DUKE POWER COMPANY

Re: Catawba Nuclear Station, Unit 1
Docket No. 50-413
Draft Technical Specifications

This letter transmits our proposed revision to Draft Technical Specification 3/4.7.8 -- SNUBBERS. The justification for the revision was discussed between Mr. Fred Anderson of your staff and representatives of Duke.

3/4.7.8 SNUBBERS

FIGURE 4.7-1
SAMPLE PLAN 2) FOR SNUBBER FUNCTIONAL TEST

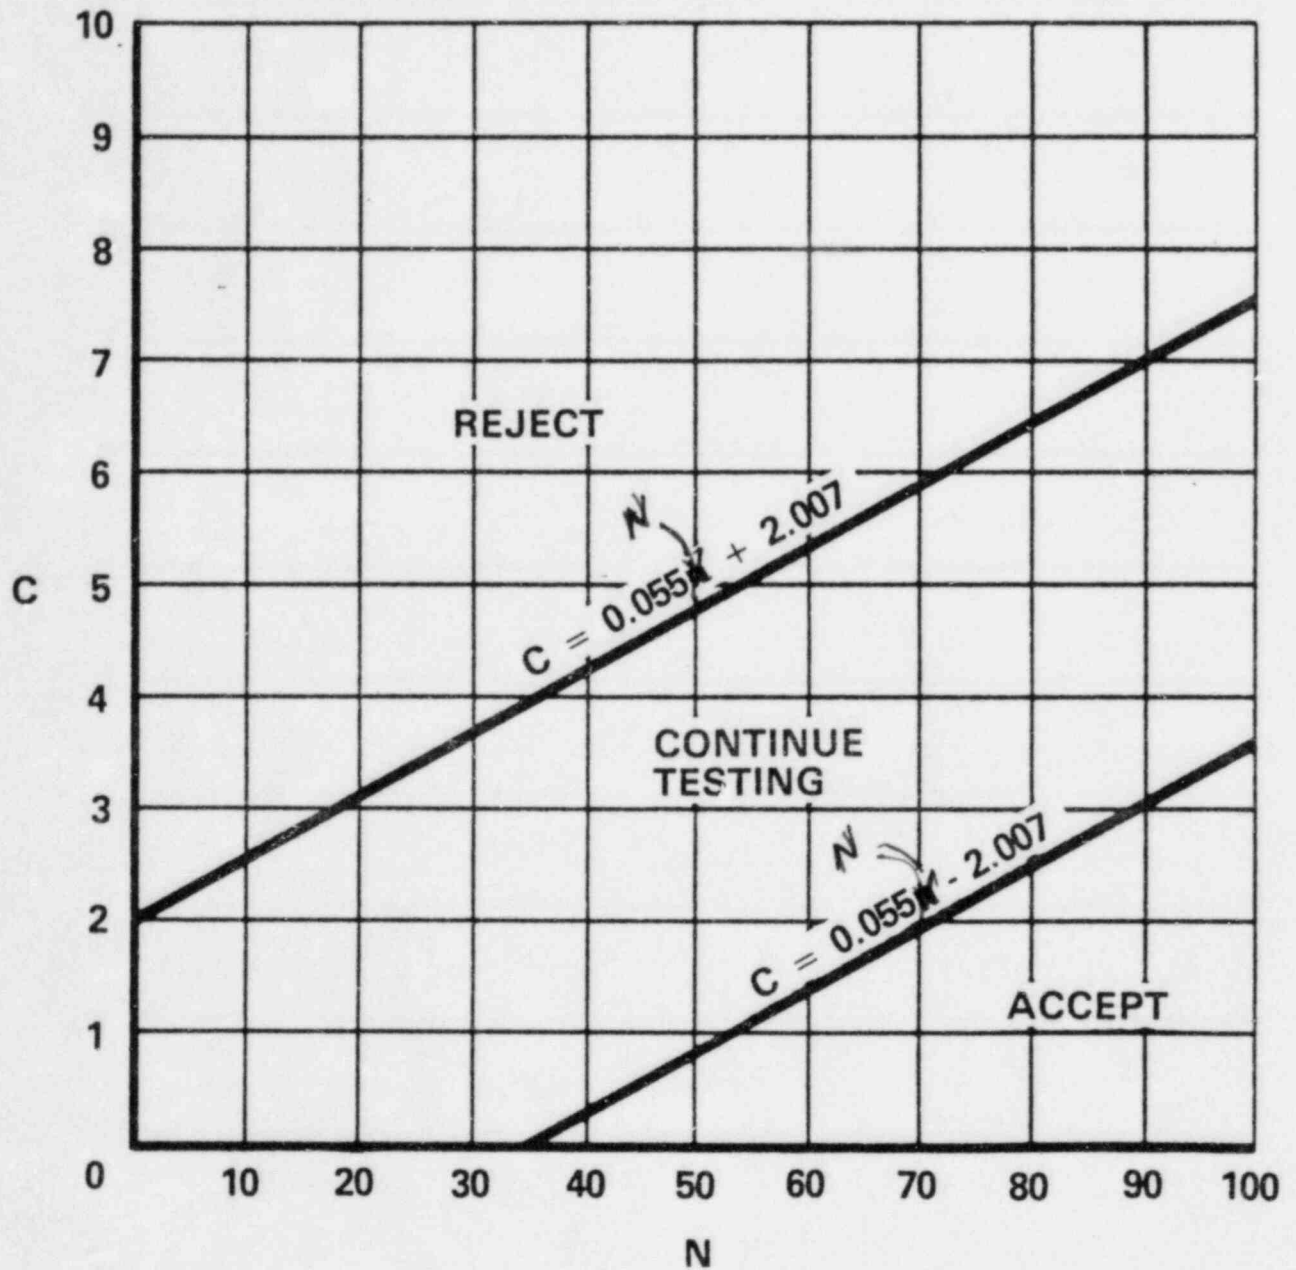
- 2) A representative sample of the snubbers required by Specification 3.7.8 shall be functionally tested in accordance with Figure 4.7-1. "C" is the total number of snubbers found not meeting the acceptance requirements of Specification 4.7.8f. The cumulative number of snubbers tested is denoted by "N." At the end of each day's testing, the new values of "N" and "C" (previous day's total plus current day's increments) shall be plotted on Figure 4.7-1. If at any time the point plotted falls in the "Reject" region all snubbers shall be functionally tested. If at any time the point plotted falls in the "Accept" region, testing of snubbers may be terminated. When the point plotted lies in the "Continue Testing" region, additional snubbers shall be tested until the point falls in the "Accept" region or the "Reject" region, or all the snubbers required by Specification 3.7.8 have been tested. Testing equipment failure during functional testing may invalidate that day's testing and allow that day's testing to resume anew at a later time, providing all snubbers tested with the failed equipment during the day of equipment failure are retested; or
